| Company | Trenz Electronic GmbH |
|------------|--|
| PCN Number | PCN-20210618 |
| Title | TE0823-01 eMMC Change and Product Update |
| Subject | BOM change |

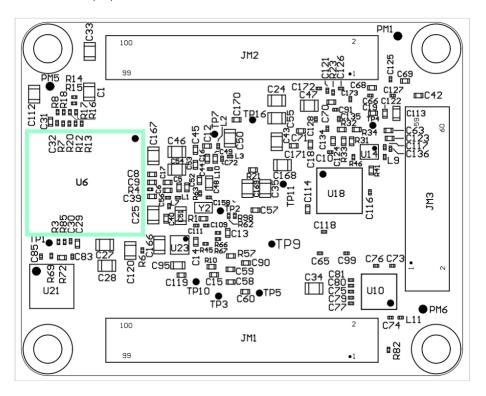
Locate eMMC (U6) on bottom side of PCB:

| old | new |
| IS21ES08G-JCLI | SDINBDG4-8G-XI2 |

2.1 #1 Change eMMC (U6) from IS21ES08G-JCLI to SDINBDG4-8G-XI2
